Woden Valley Community Council Inc.

Submission

Draft Variation to the Territory Plan No 344

Woden Town Centre

Figure 42: Proposed building heights

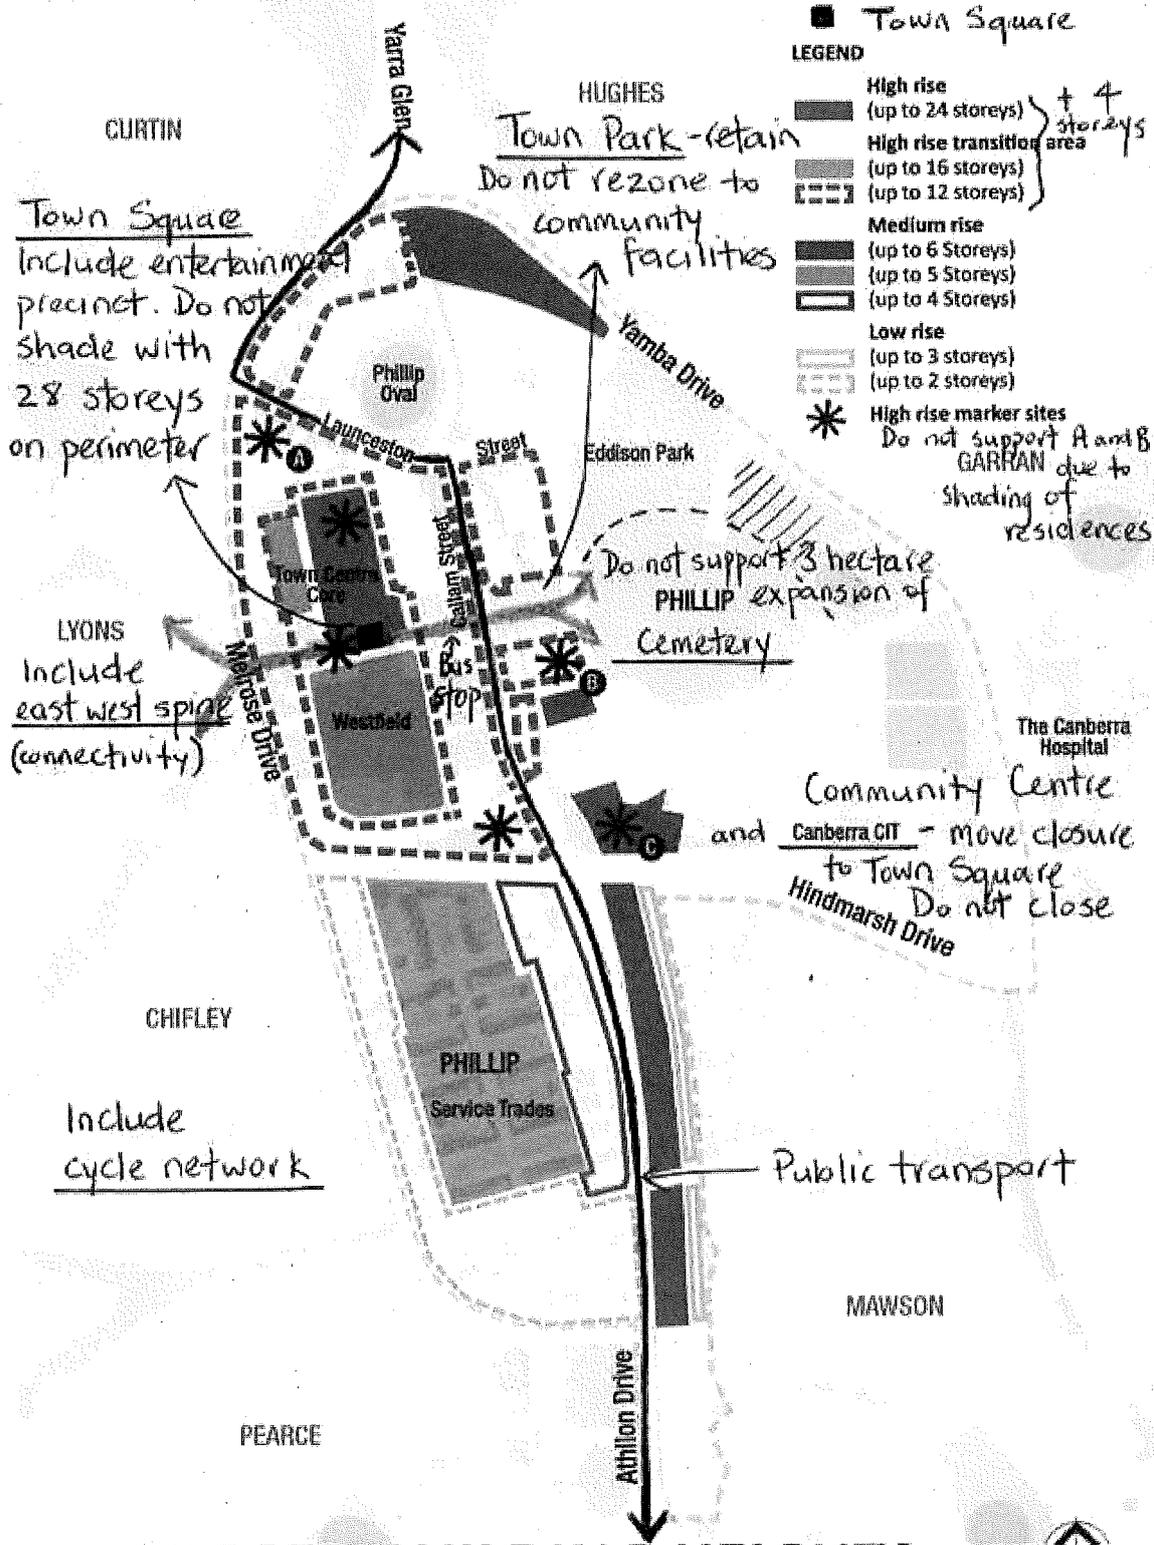
1. Densification (building heights should be lower and stated in metres)
2. Town Square – as the central activity point, retention of the current buildings on the perimeter for solar access in the cooler months;
3. East west spine – retention of solar access;
4. Agglomeration of activity in a central area - identification of sites so the area is not built out:
 - a. an entertainment precinct;
 - b. a higher education facility;
 - c. a community/arts centre;
 - d. a pool;
 - e. a multi-purpose sports hall;
5. Active living/ connectivity - identification of alignments for cycle paths;
6. Identification of open green spaces, including.
 - a. retention of Arabanoo Park as open space

Woden 1970 map – shows community facilities on east west spine

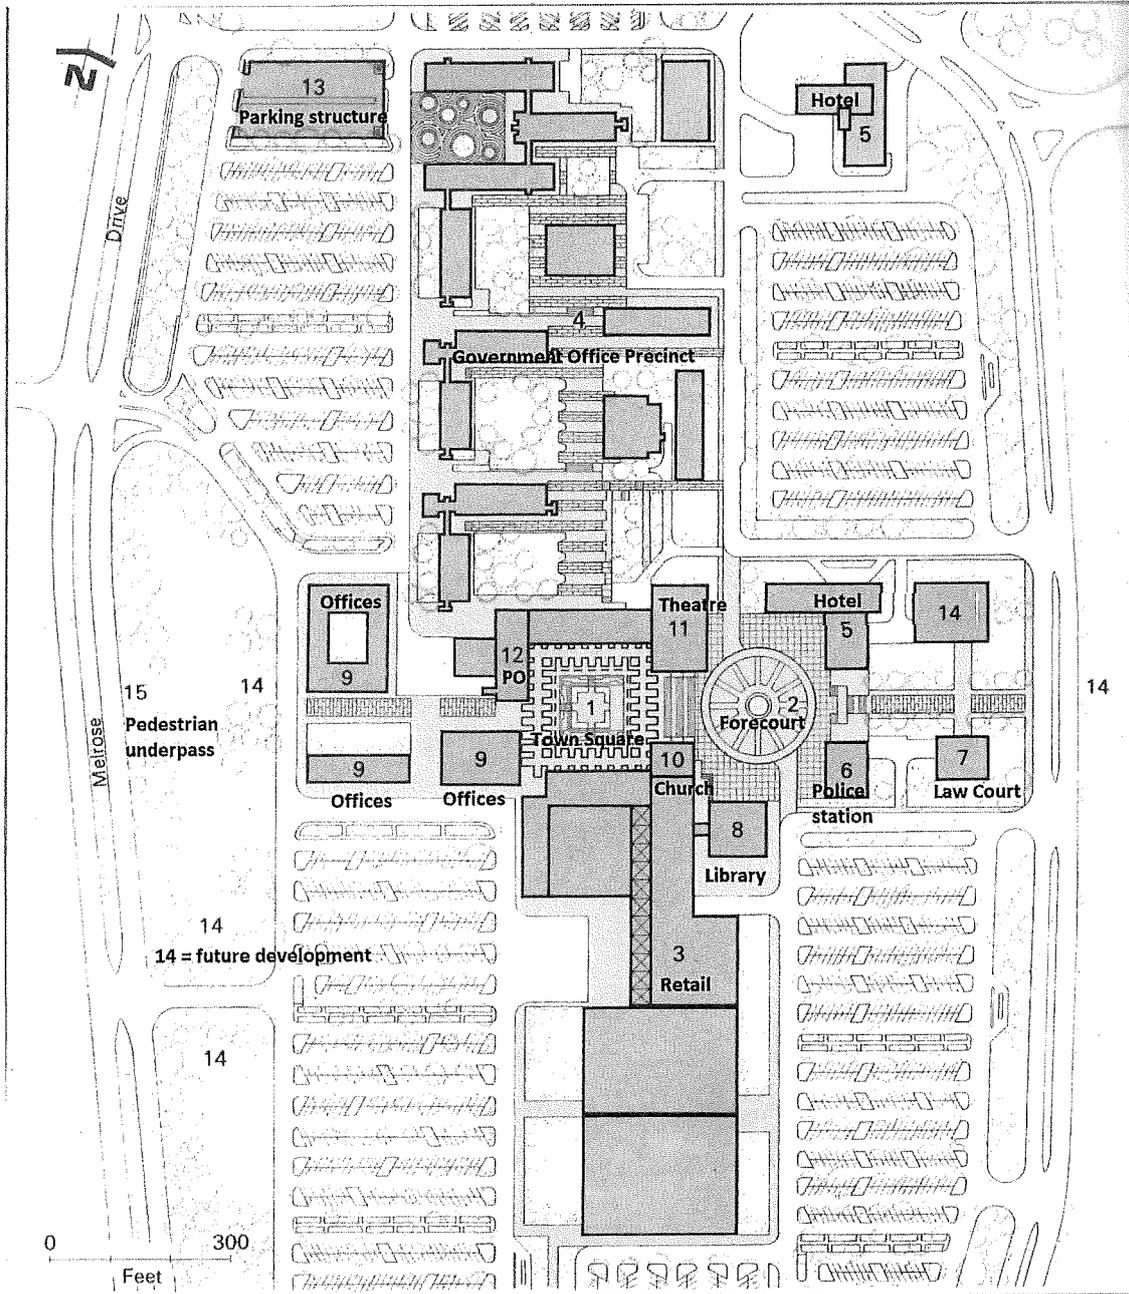
The draft Precinct Code provides for building heights and setbacks however it does not provide for community facilities. The 2015 Master Plan diminishes the benefits of the 2004 Master Plan by ceasing to provide a map that identifies community facilities. See 1970 map at **Attachment C** and the 2004 map at **Attachment D**.

Areas subject to rezoning

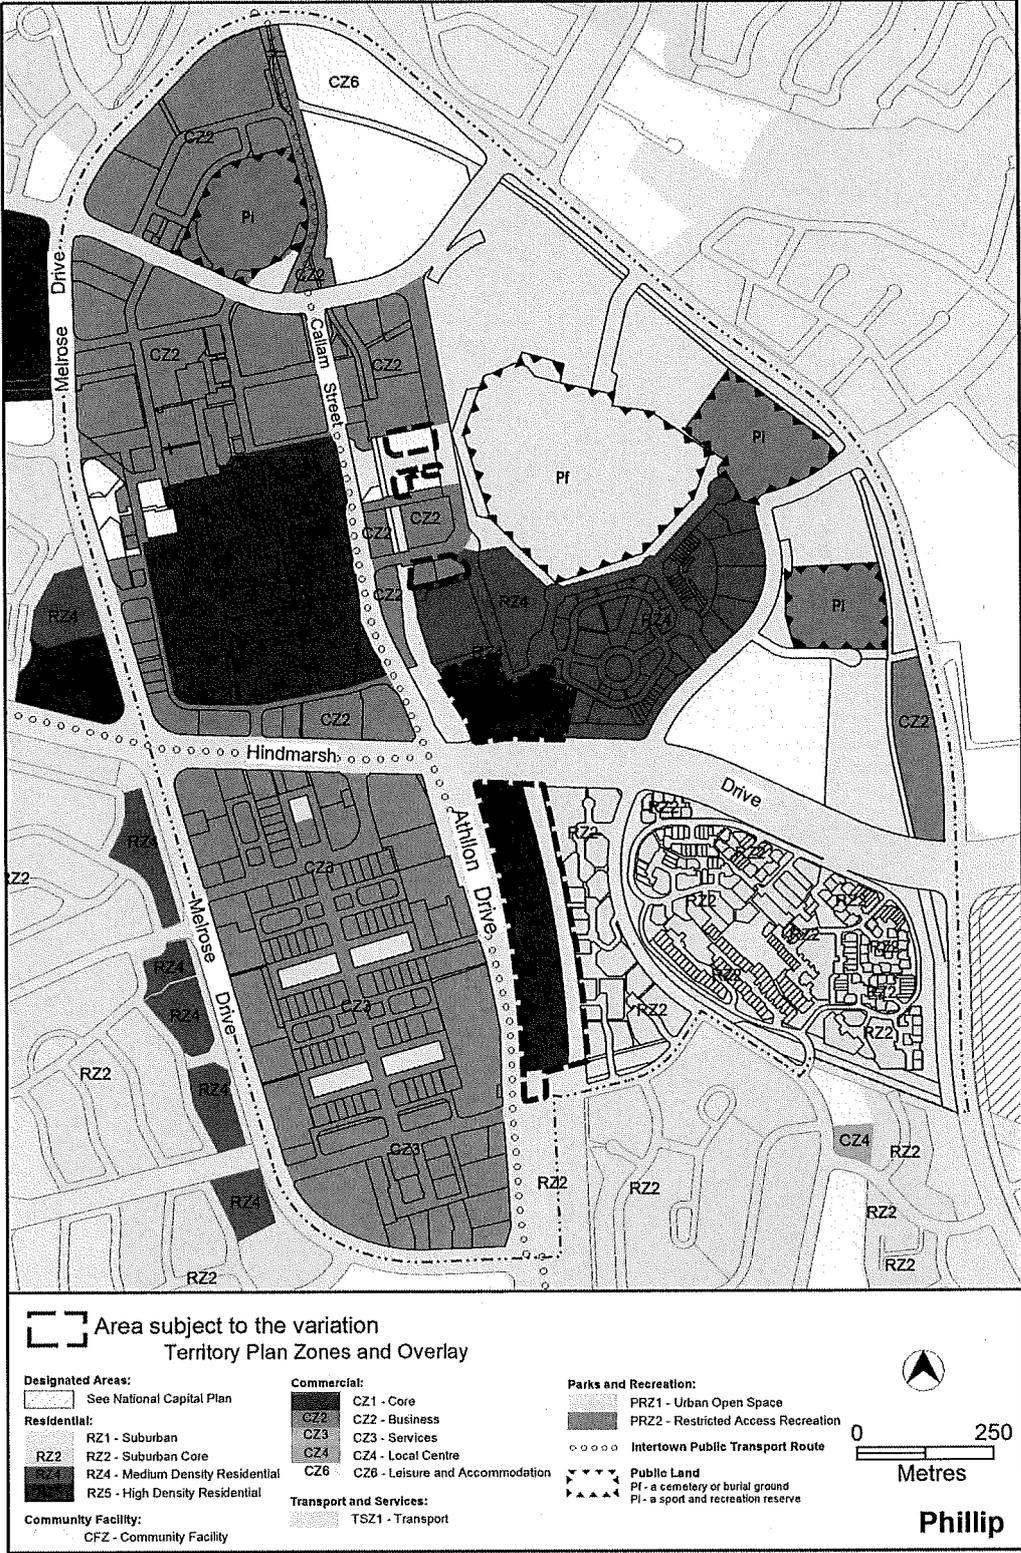
The WVCC **does not support** rezoning Woden Park/Arabanoo Park as the Town Centre is abundant with empty blocks and carparks that could be used for community facilities and the case to rezone this open space has not been made.

- Retain Arabanoo Park as open green space

Overshadowing of the Woden Town Square

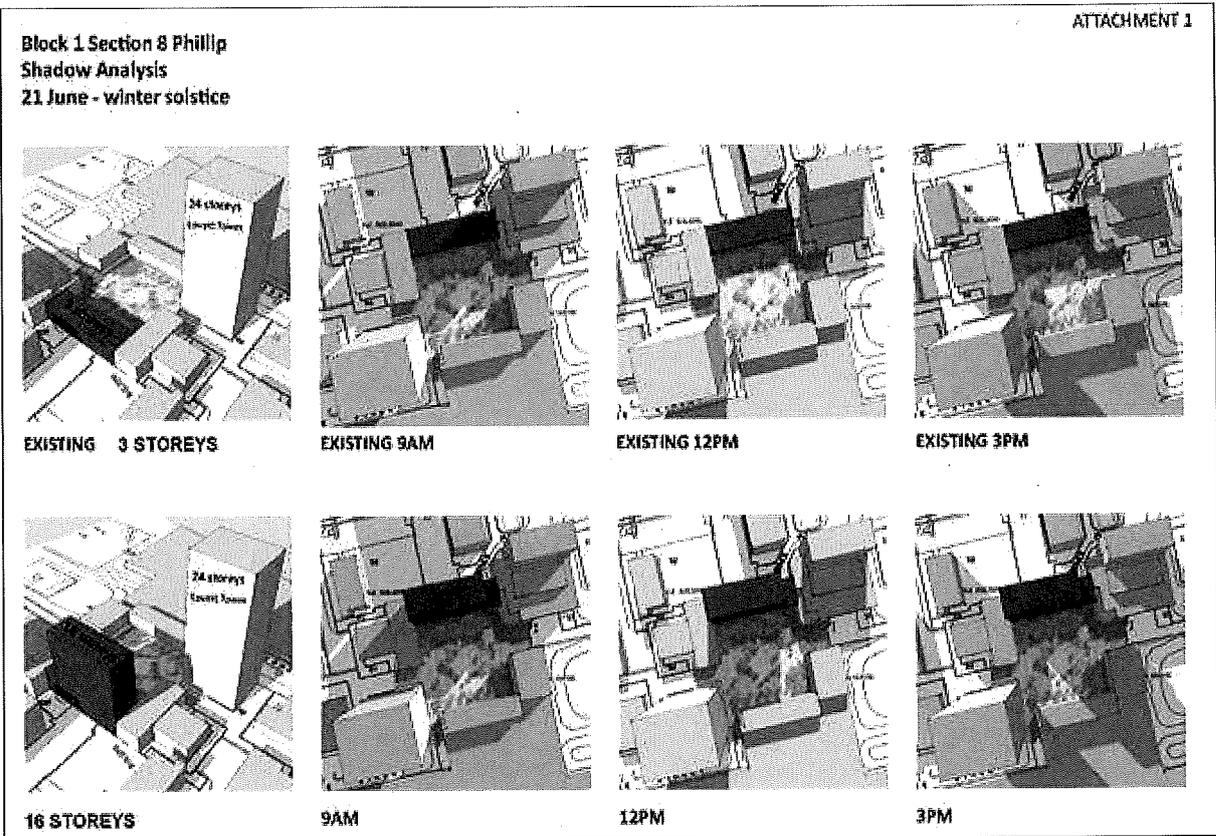
The draft Precinct code provides for 28 storey buildings around the Town Square which will make it difficult for the Square to become 'attractive' and 'comfortable' for the community. The overshadowing is likely to continue the current situation of people moving through the square and not stopping, leading to a continuation of the lack of activity in the square.

This will provide very poor outcomes for Woden residents. Overshadowing map at **Attachment F**.

Figure 1 Existing car parks, active frontages and community recreation facilities – however there are no community facilities identified

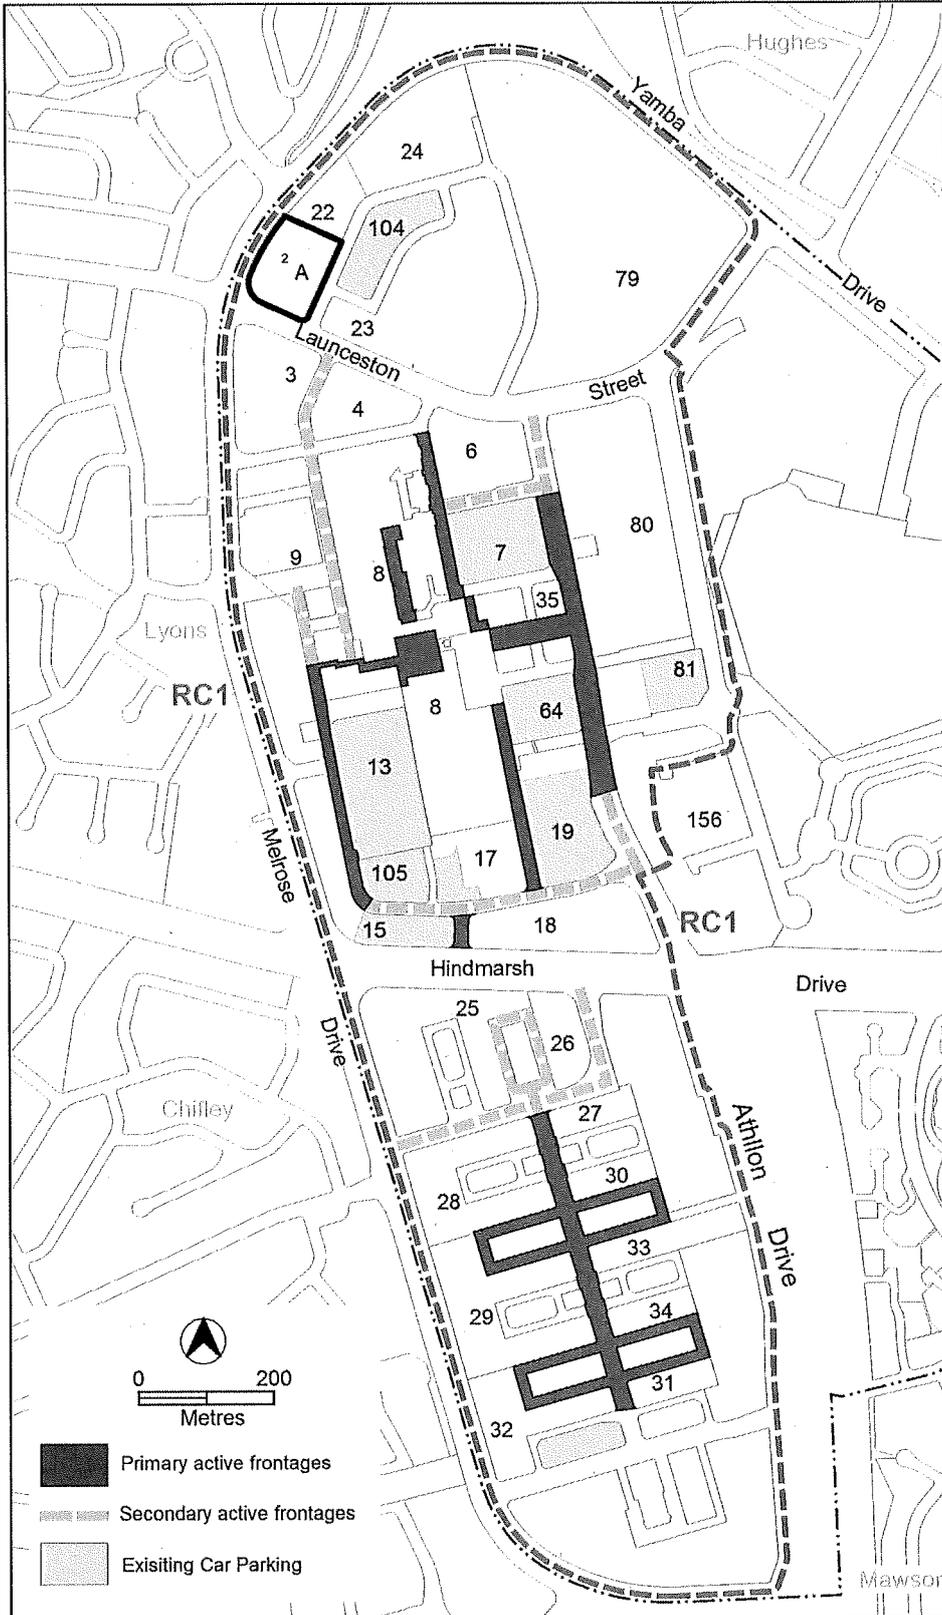
The title of Figure 1 includes community recreation facilities but does not identify any. This is an oversight and we request that the community recreation facilities be included in the diagram. The WVCC supports the statement in the Master Plan that community and educational facilities should be located strategically to strengthen the pedestrian network and create more diverse and lively areas. Figure at **Attachment G**.

Proposed building heights

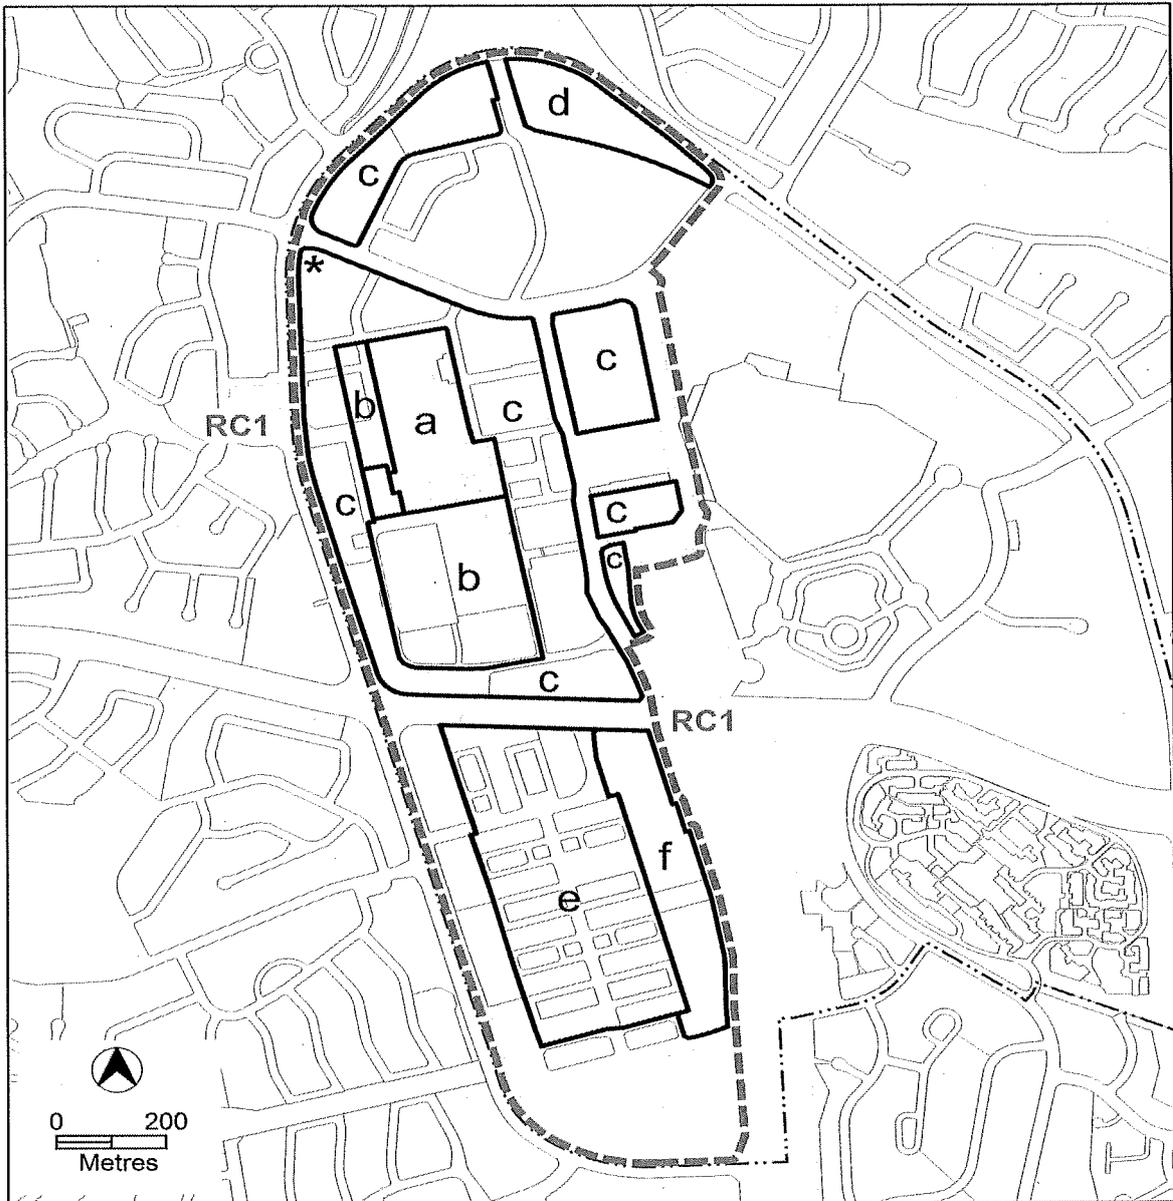
Building heights on the perimeter of the Town Square should remain at 3 storeys to provide sun into the Town Square. Higher buildings cause unacceptable overshadowing. Proposed building heights are at **Attachment H**.

a - 12 to 16 storeys with the existing 3 storeys on the Town Square

b - 12 to 16 storeys

c - 4 to 6 storeys on Callum Street (entertainment precinct)

c - 4 to 6 storeys on Melrose Drive

c - 12 to 16 storeys on Hindmarsh Drive (shades the road)

d - 5 to 6 storeys

e - 5 to 6 storeys

f - 4 storeys but in a PD 3 area (prohibited residential use)

Building heights of 4 to 6 (medium rise) adjacent to the suburbs with 6 to 8 storeys for 'transitional' areas (with big trees in front) for human scale. Some taller, 12 to 16 storey buildings, should only be permitted where they do not overshadow public spaces or other residential
